**RE: REVISED GRADING PLAN: REMEDIAL ACTION WORK PLAN
SUN CHEMICAL, SITE #C243024
441 TOMPKINS AVENUE, STATEN ISLAND, NEW YORK**

**DESIGN CALCULATIONS
PROPOSED SLOPE ARMORING DESIGN**

PROPOSED CAPPING PLAN

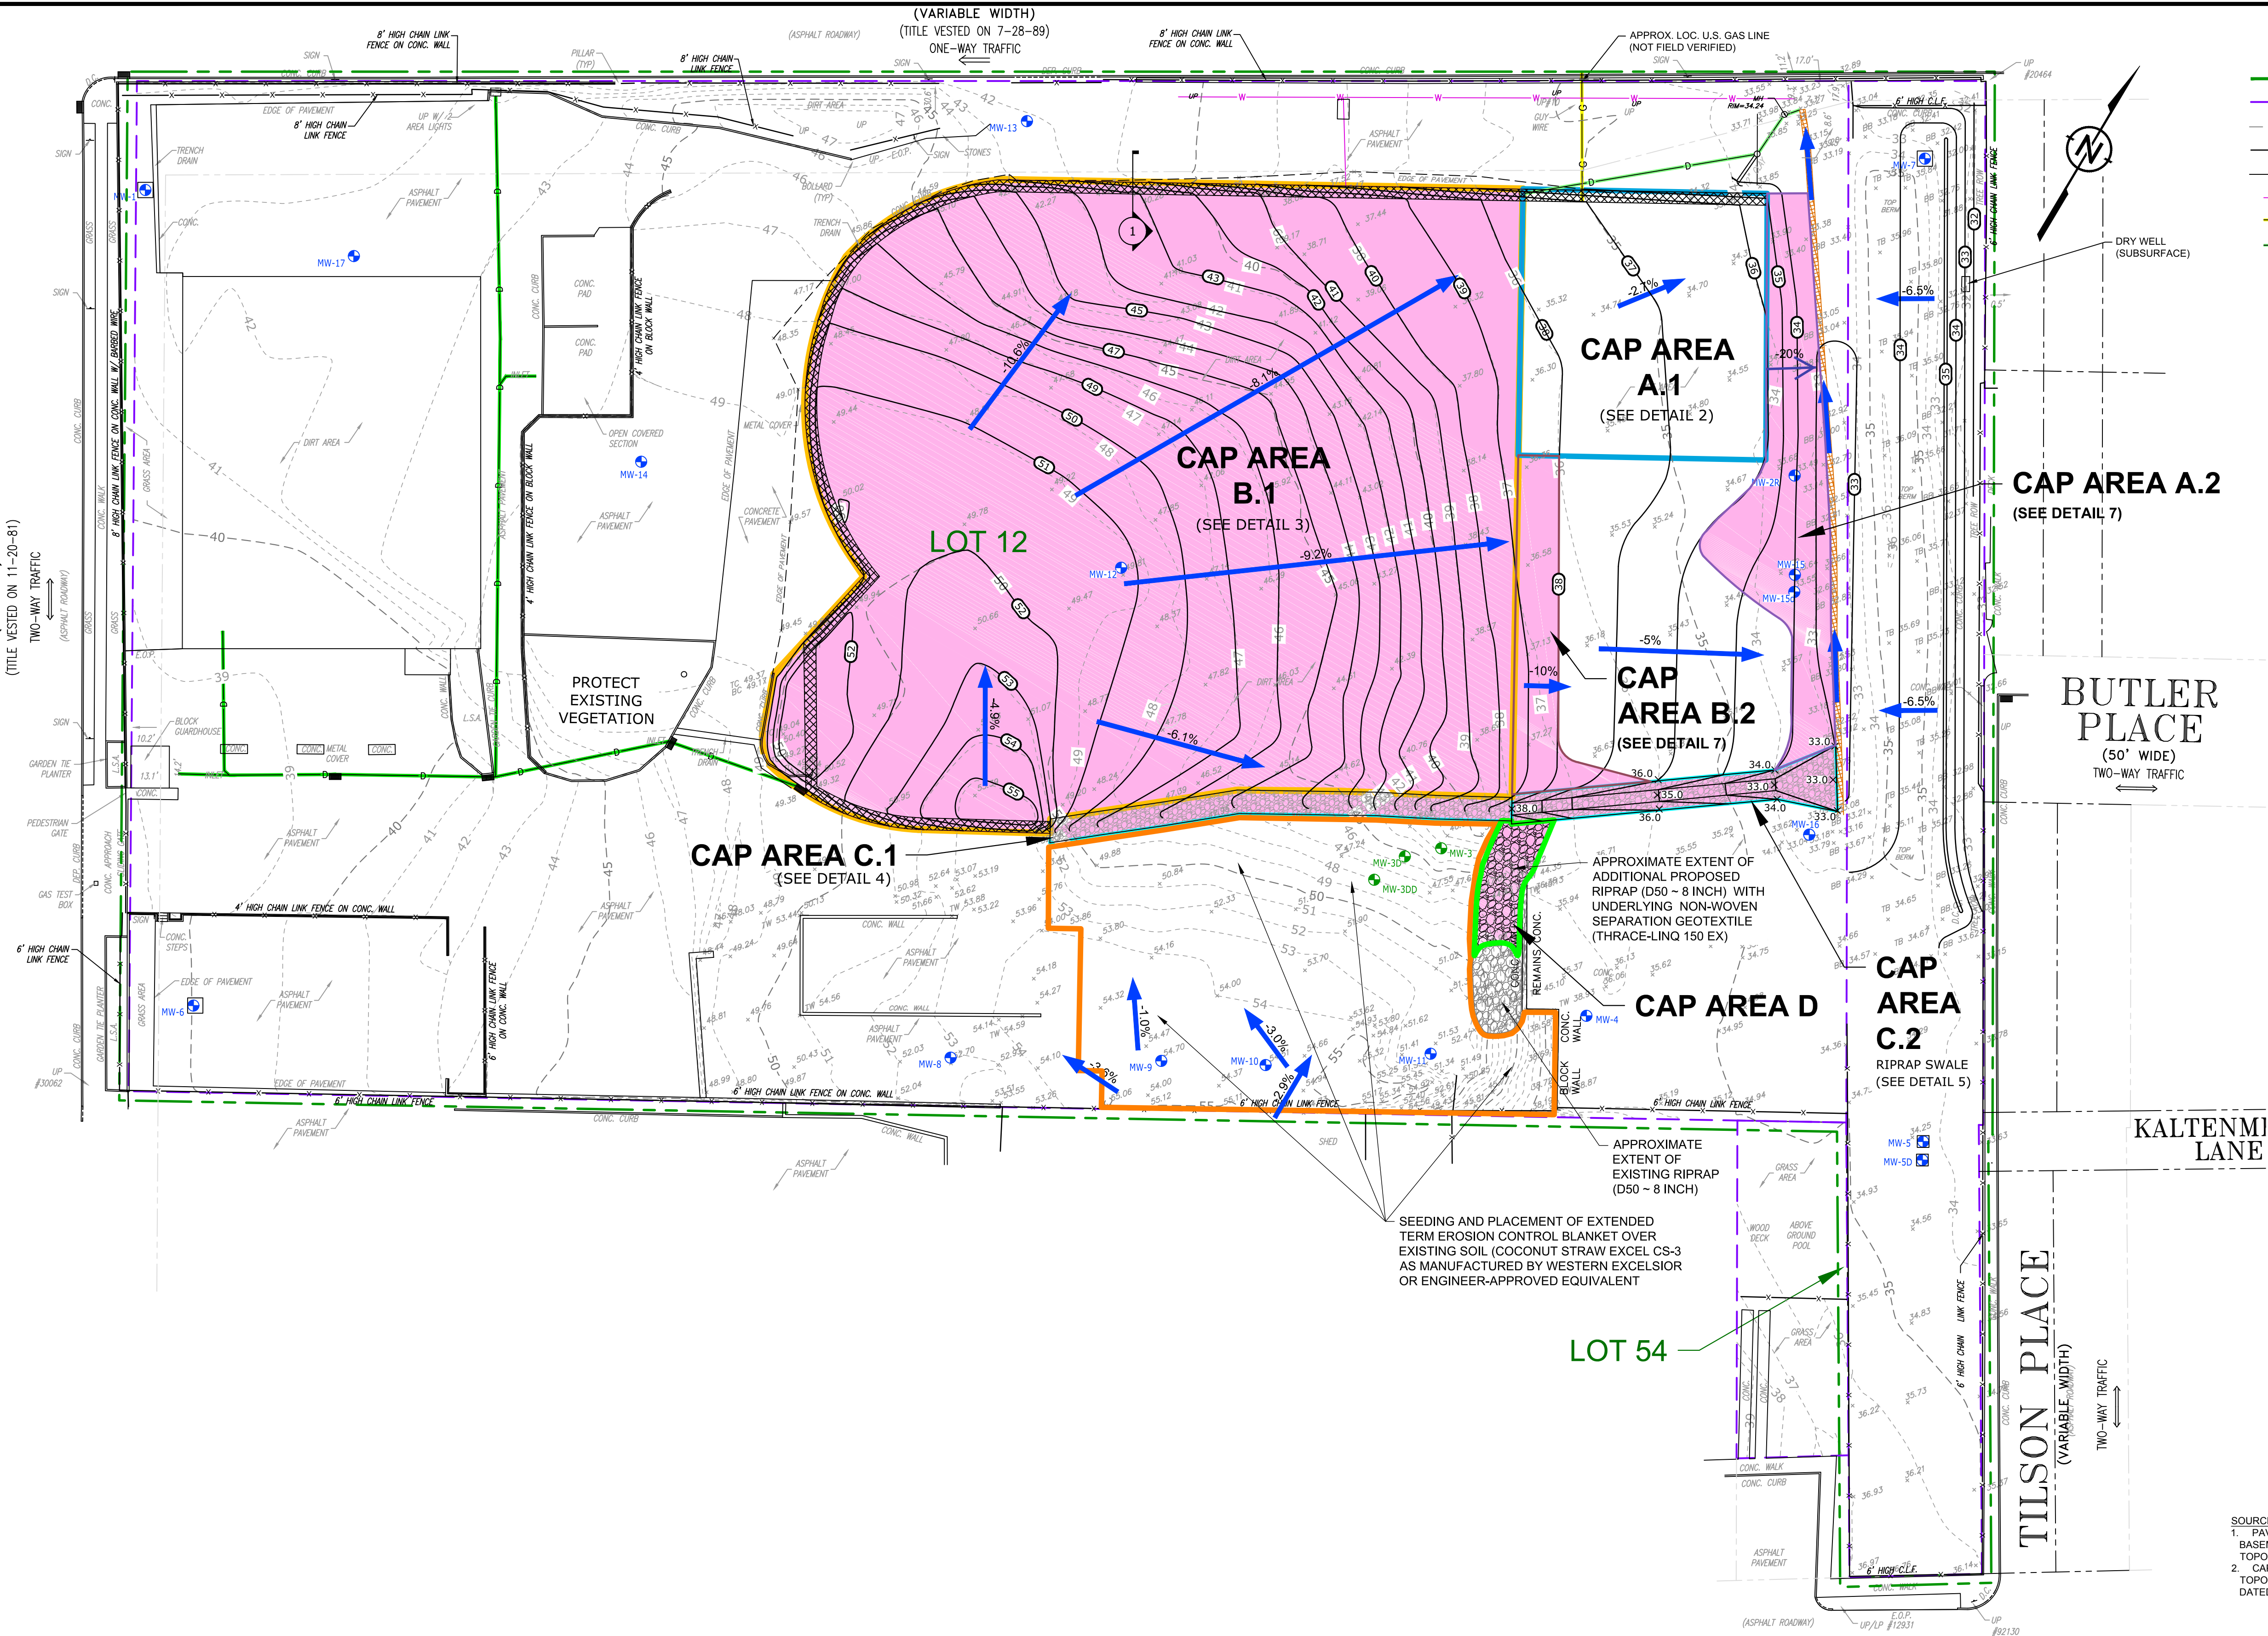
1. AOC 2 Berm: A berm had previously been approved along the northern portion of AOC 2 to better manage post-remedial storm water flow. The attached plan modifies that berm to be in closer proximity to the eastern property boundary, further limiting the storm water flow that can drain off of the site and directing the storm water flow in the westerly direction, towards the existing interceptor trench.

2. Cap Area C: An extension of the drainage swale in Cap Area C.1 (Cap Area C on the previous plan) is proposed (see "Cap Area C.2") to connect Cap Area C.1 to the southern/upgradient end of the interceptor trench. This modification will further limit potential erosion at the toe of the slope resulting from large storm events. Construction of Cap Area C.2 will conform to Detail #5 in the attached drawings.

3. Cap Area D: This capping area was added to address DEC's erosion concerns regarding the sloped exposed soil area west of the retaining wall, and consists of extending the current riprap cover adjacent to that wall northward for additional erosion protection. As shown, the riprap capping in Cap Area D will terminate at the proposed swale in Cap Areas C.1 and C.2. These modifications will supplement the previously proposed / approved addition of seeding and the coconut-fiber erosion control blanket to the south of Cap Area B.1.

DETAIL 3
CAP AREA B.1
TYPICAL CROSS SECTION
1" = 2'

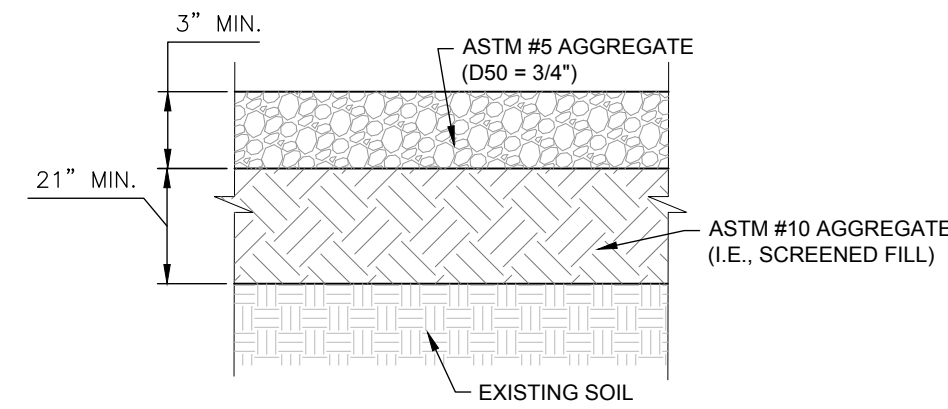
¹ Note that Detail 3 in Attachment A depicts ASTM #5 stone armoring instead of ASTM #7 or 67 because the remediation contractor inadvertently had ASTM#5 delivered instead. This alternate stone aggregate is acceptable because it is coarser than ASTM #7 or 67, which is the minimum required stone size for armoring.

DETAIL 5
RIPRAP SWALE FOR CAP AREA C.2
1" = 2'

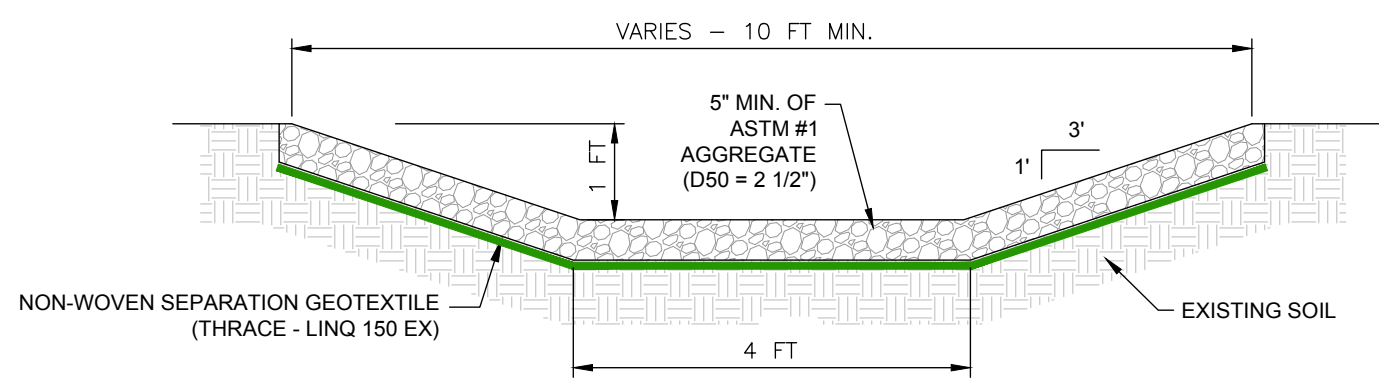
For ease of construction, it was decided to apply the stone lining requirements for the riprap apron to Cap Area C.2 (i.e., use the larger ASTM #1 stone instead of ASTM #5 stone).
